# UNITED STATES PATENT AND TRADEMARK OFFICE

APPLICATION NO.	FILING DATE	FIRST NAMED INVENTOR	ATTORNEY DOCKET NO.	CONFIRMATION NO.
10/629,825	07/30/2003	James R. Ellsworth	70869-0113US	7295
22902	7590	02/16/2006	EXAMINER	
CLARK & BRODY 1090 VERMONT AVENUE, NW SUITE 250 WASHINGTON, DC 20005			COOLEY, CHARLES E	
			ART UNIT	PAPER NUMBER
			1723

## **FINAL OFFICE ACTION**

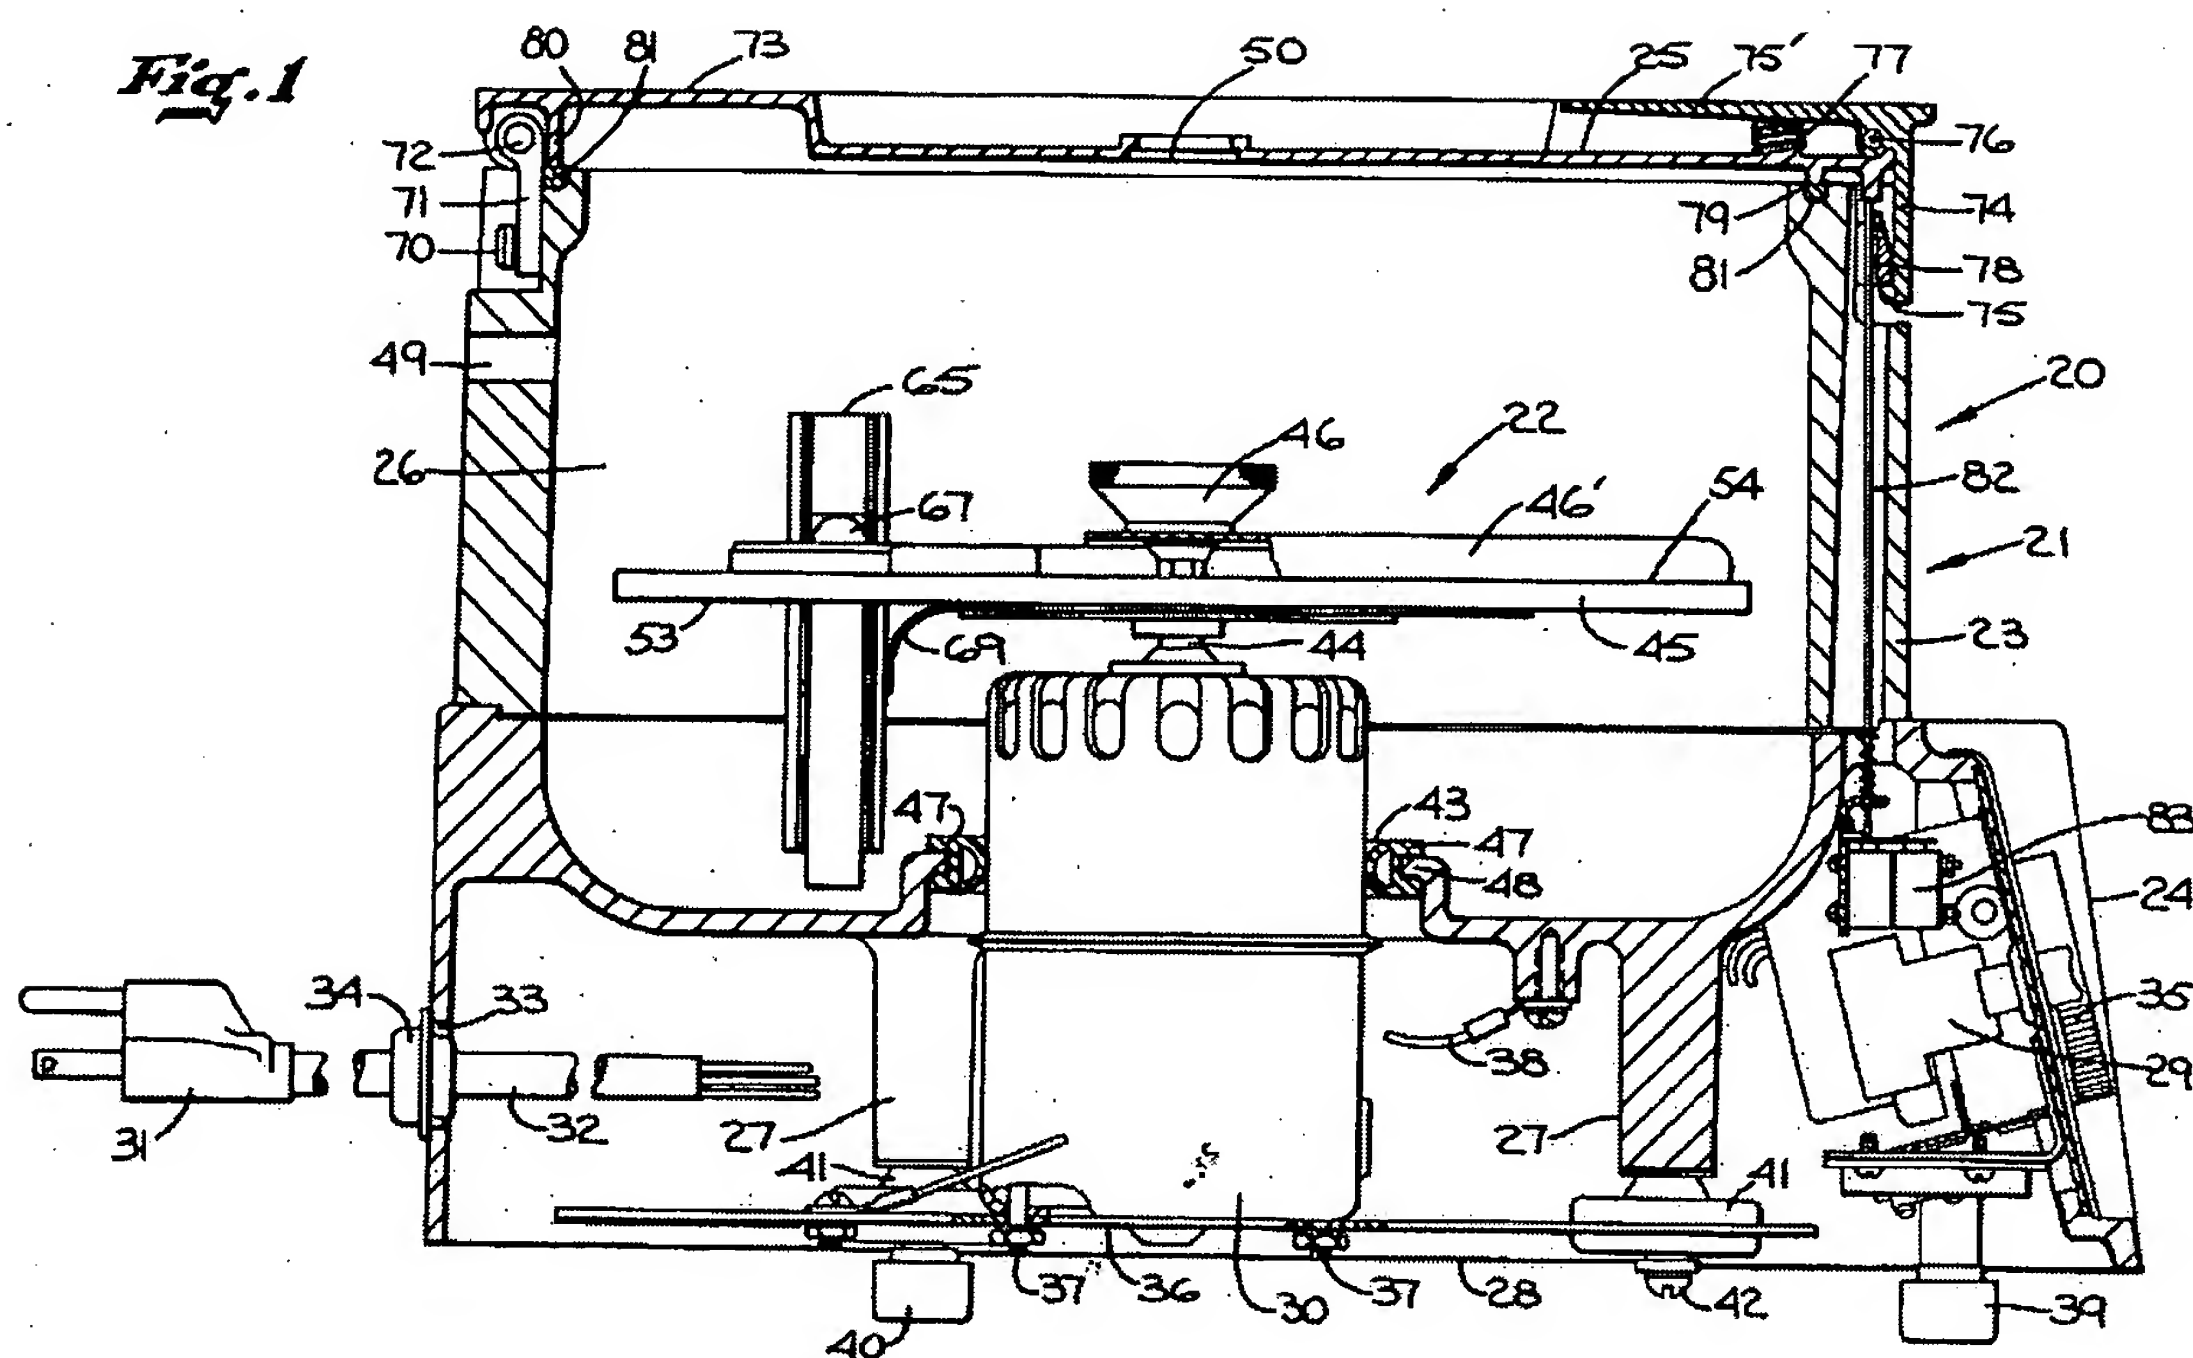
With regard to claims 1-2, the patent to Smith et al. discloses, as seen below, a centrifuge comprising a base 36 having feet 40; an enclosure 21, 26, 27 mounting a motor 30; a rotor 45 mounted on the motor; an isolator support 42 secured to the base 36 and extending between the base and the enclosure; a vibration isolator 41 mounted to the isolator support 42 and to a portion 27 of the enclosure 21, 26, 27; wherein said vibration isolator 41 engages said enclosure at a location that is substantially aligned with the force applied by said rotor resulting from imbalance of said rotor (col. 3, lines 37-41 and col. 7, lines 51-56).

With regard to newly presented claim 5, the patent to Smith et al. discloses, as seen below, a centrifuge comprising a base 36 "configured to" be supported on a stationary surface under the feet 39 and 40, an enclosure 21, 27 "configured to" support a rotor 45 and a drive mechanism 30; a support 42 mounted to said base 36 and extending away from said base to a location adjacent (i.e., below said rotor and within the centrifuge structure), and a vibration isolator 41 mounted to said support 42 at said location and to said enclosure.

Although Smith et al. shows a rotor and drive mechanism, the claim language following "configured to" in claim 5 is merely an intended use of the enclosure and fails to positively recite a rotor and drive mechanism. Regarding the "configured to" language added to the amended claims, according to MPEP 2106, the subject matter of a properly construed claim is defined by the terms that limit its scope. It is this subject matter that must be examined. As a general matter, the grammar and intended meaning of terms used in a claim will dictate whether the language limits the claim scope.

**11. Claim 5 is rejected under 35 U.S.C. 102(b) as being anticipated by JP 62-236593.**

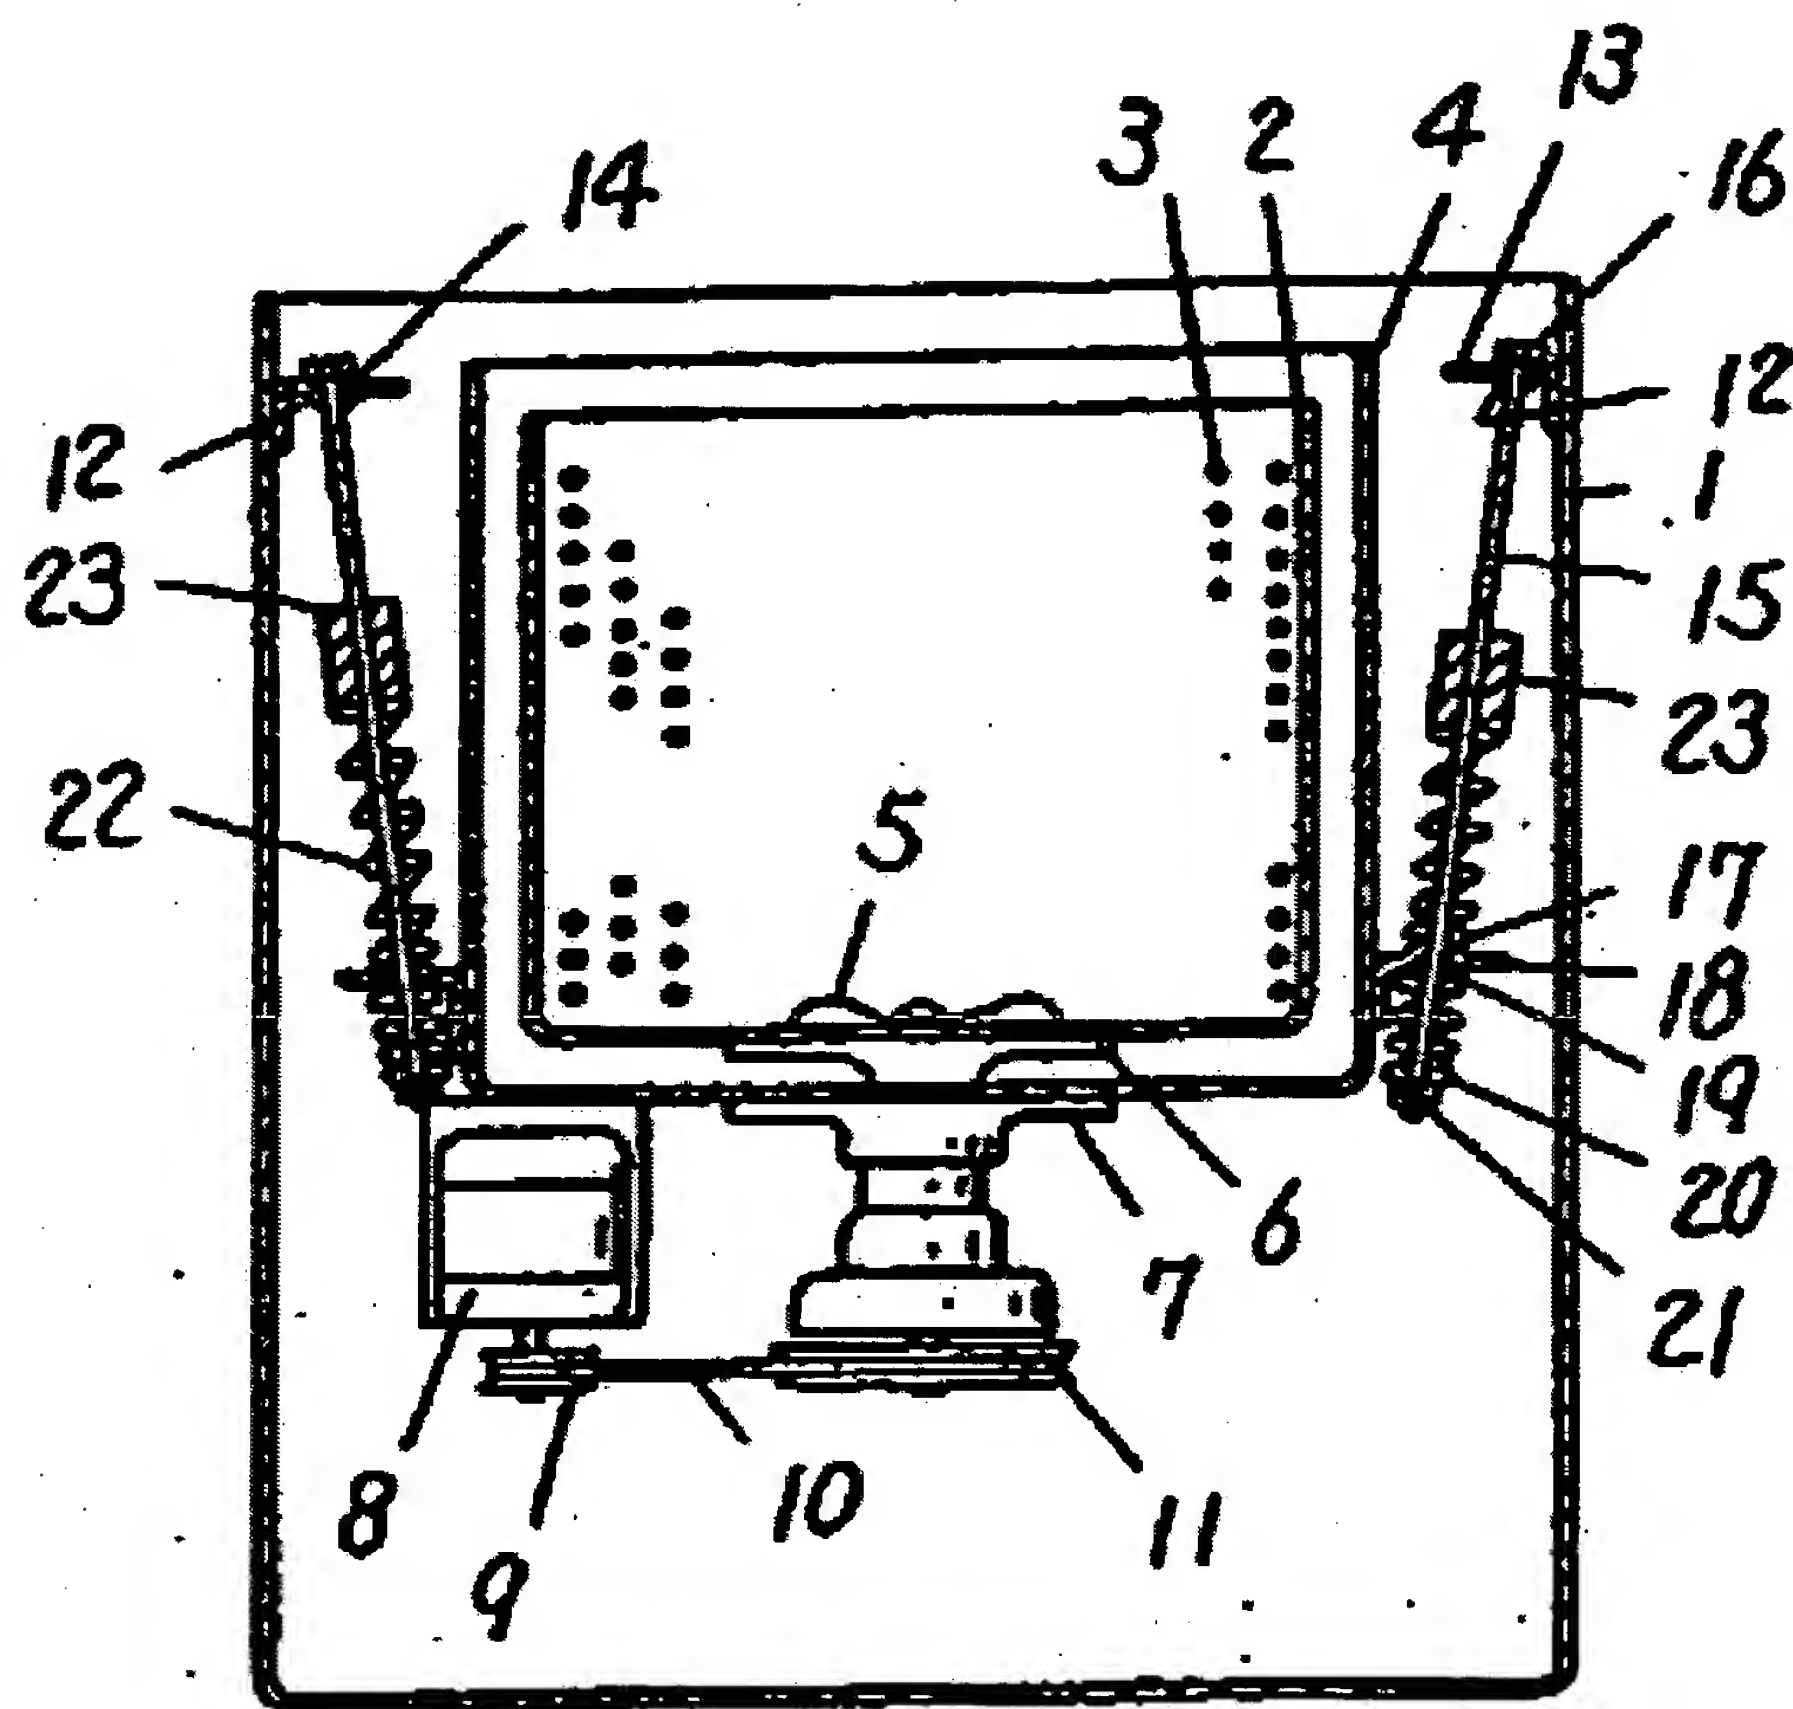
With regard to newly presented claim 5, JP 62-236593 discloses, as seen below, a centrifuge comprising a base 1 “configured to” be supported on a stationary surface, an enclosure 4 “configured to” support a rotor 2 and a drive mechanism 8; a support 13 and/or 15 mounted to said base 1 and extending away from said base to a location adjacent (i.e., laterally disposed with respect to the rotor or within the plane of rotation of the rotor 2), and a vibration isolator 22 mounted to said support 15 at said location and to said enclosure 4.

**12. Claim 5 is rejected under 35 U.S.C. 102(b) as being anticipated by Stallmann (US 3,606,143).**

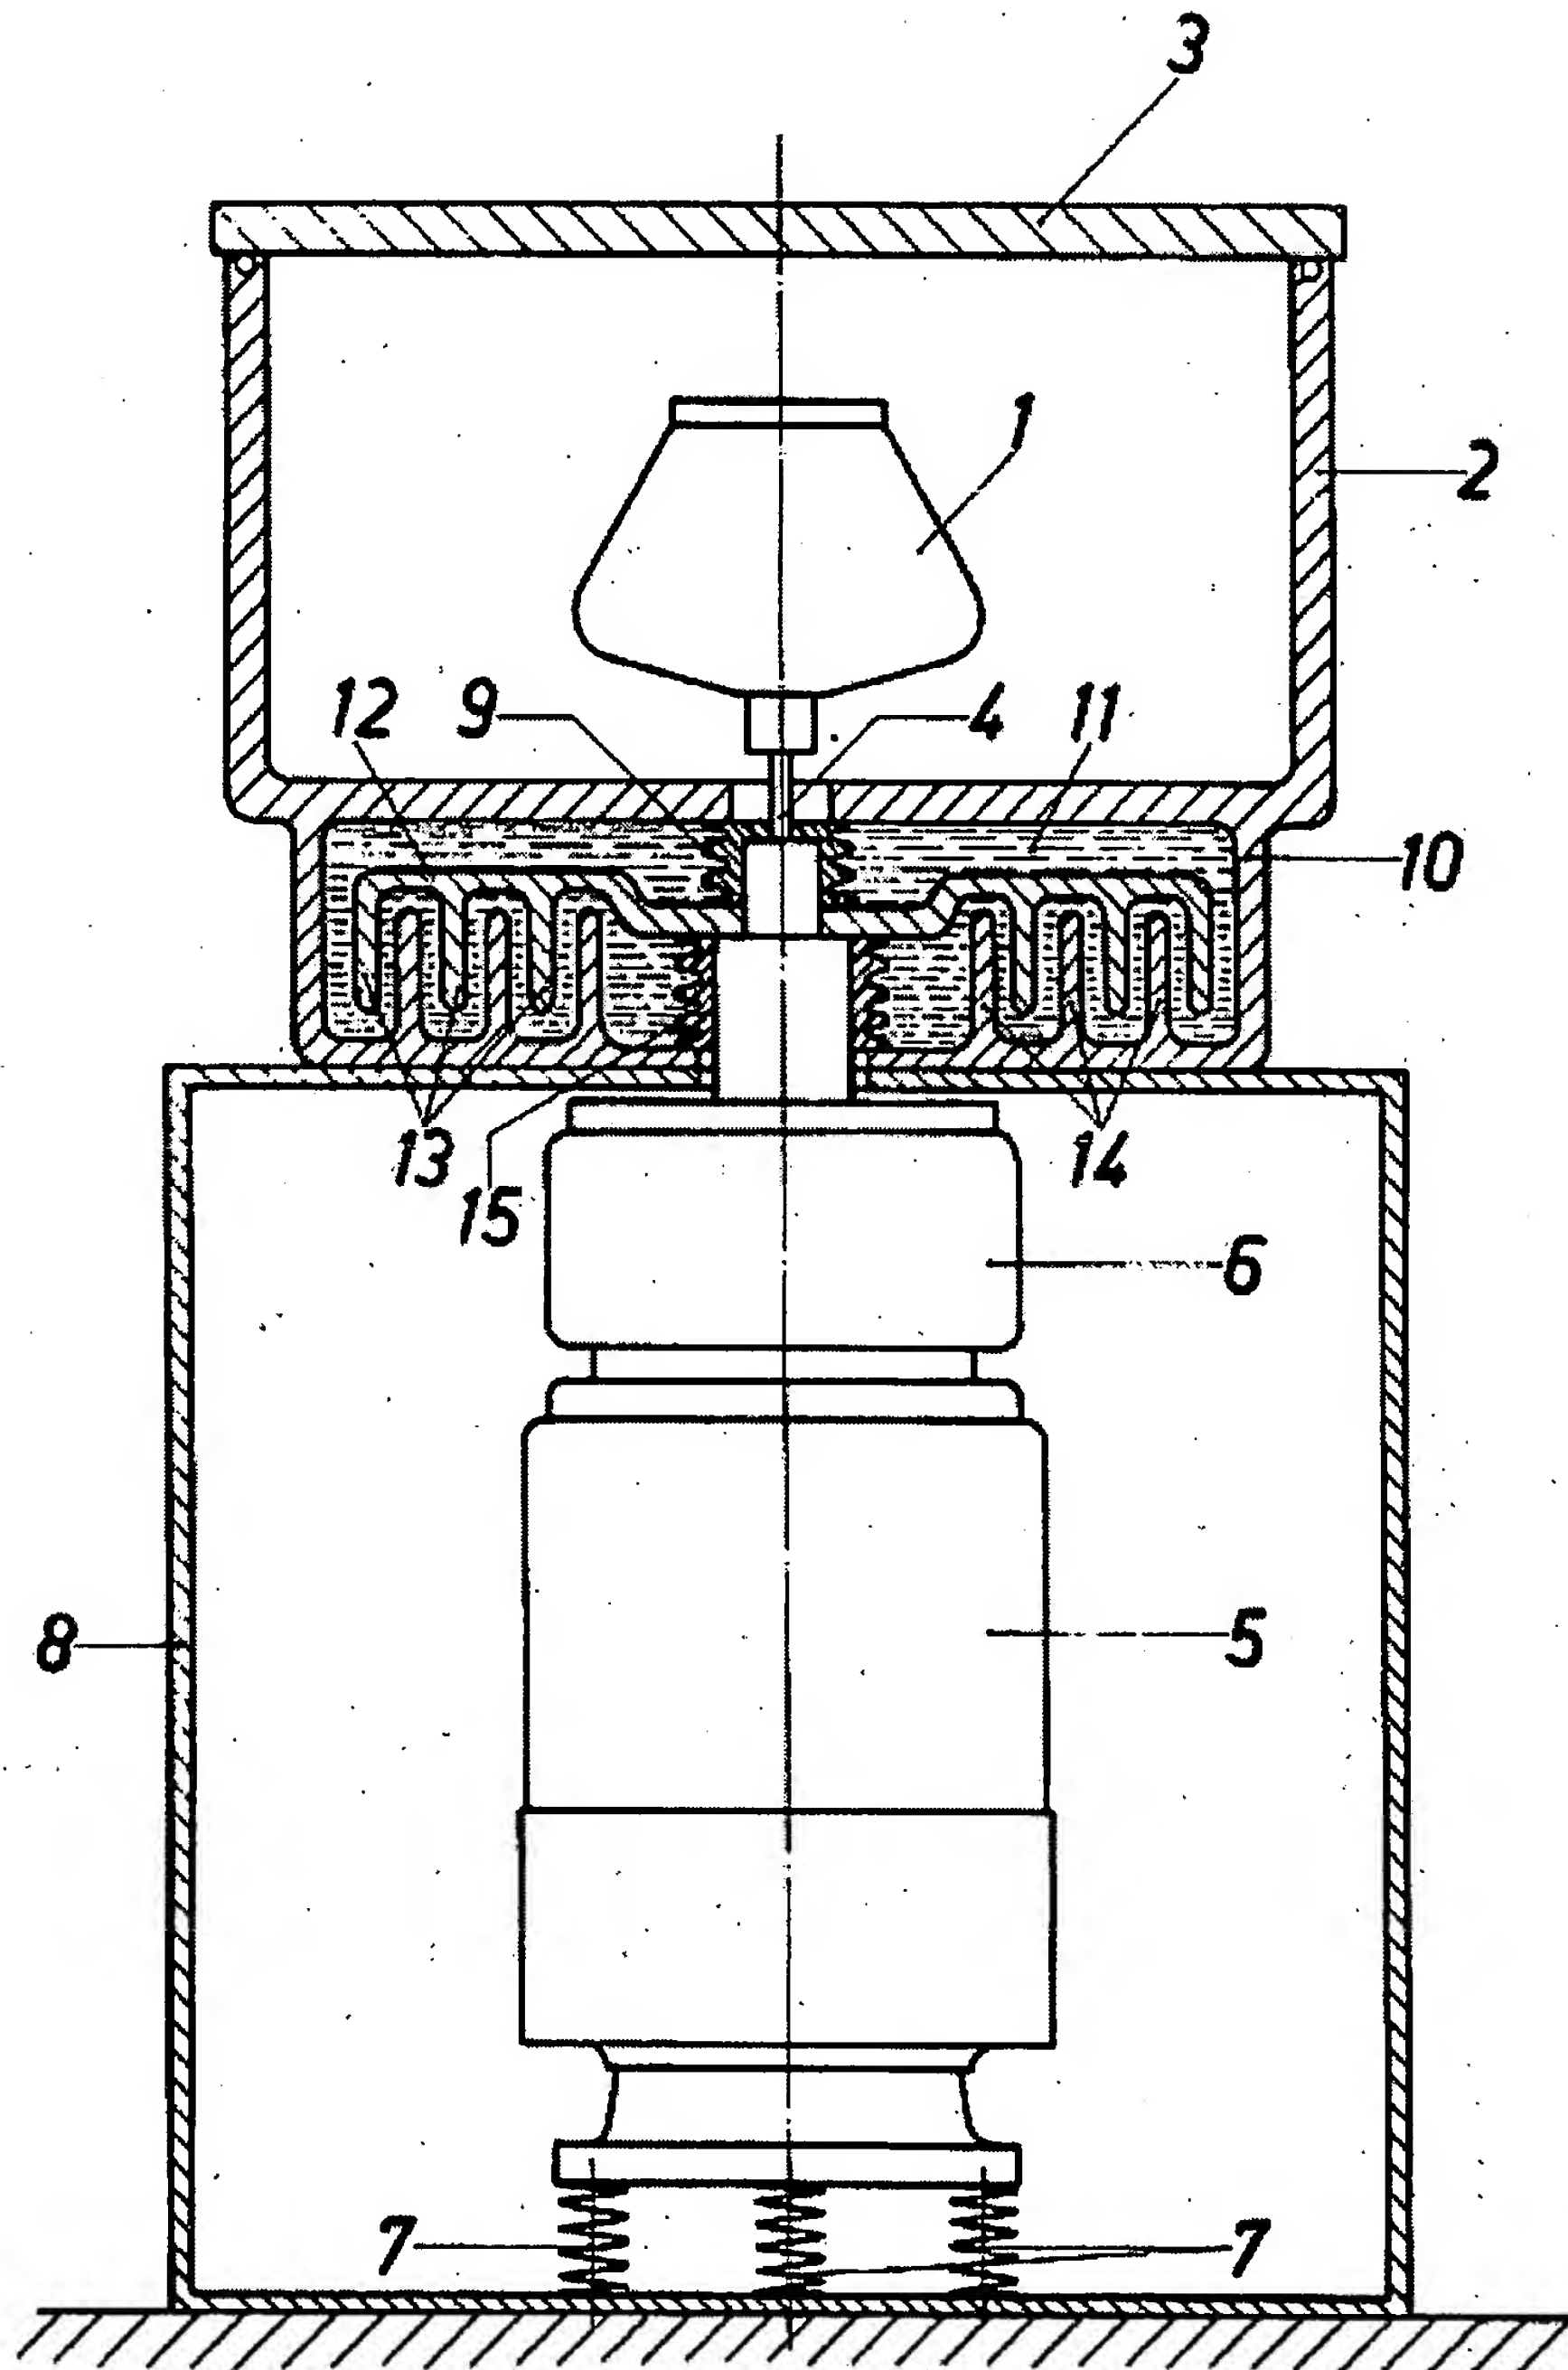
With regard to newly presented claim 5, Stallmann '143 discloses, as seen below, a centrifuge comprising a base (below 7) "configured to" be supported on a stationary surface, an enclosure 8 "configured to" support a rotor 1 and a drive mechanism 5; a support 10 mounted to said base 8 and extending away from said base to a location adjacent (i.e., below the rotor 1), and a vibration isolator portion 11, 14 mounted to said support 10 at said location and to said enclosure 8.
